Access Compliance Report Public Rights-of-Way (RR Crossings)

Intersection ID: 10035376	Main Street: RAMA_RD	Location: N/A
ADA ID: 345023C6D24E	Overall Compliance: No	Severity Score: 0.0
Codes/Mitigation Info/Possible Solution		Field Measurements/Component Compliance

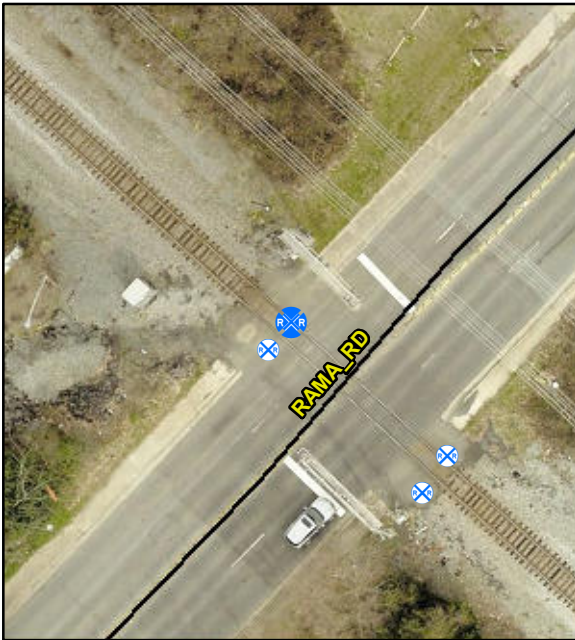
Compliance	Description	Data
No	DWS Provided?	No
N/A	DWS Contrast?	No
N/A	DWS Width (in)	No
N/A	DWS Length (in)	N/A
N/A	DWS Offset (in)	N/A
No	Pedestrian Gate?	No
N/A	DWS Outside Gate?	No
N/A	Rail Type?	Freight
No	Flangeway Gap (in)	3.0
Yes	Sidewalk Width (in)	60.0

**Install Detectable Warning System.
Provide Pedestrian Gate. Remove &
Replace Walking Surface Adjacent
to Rail.**
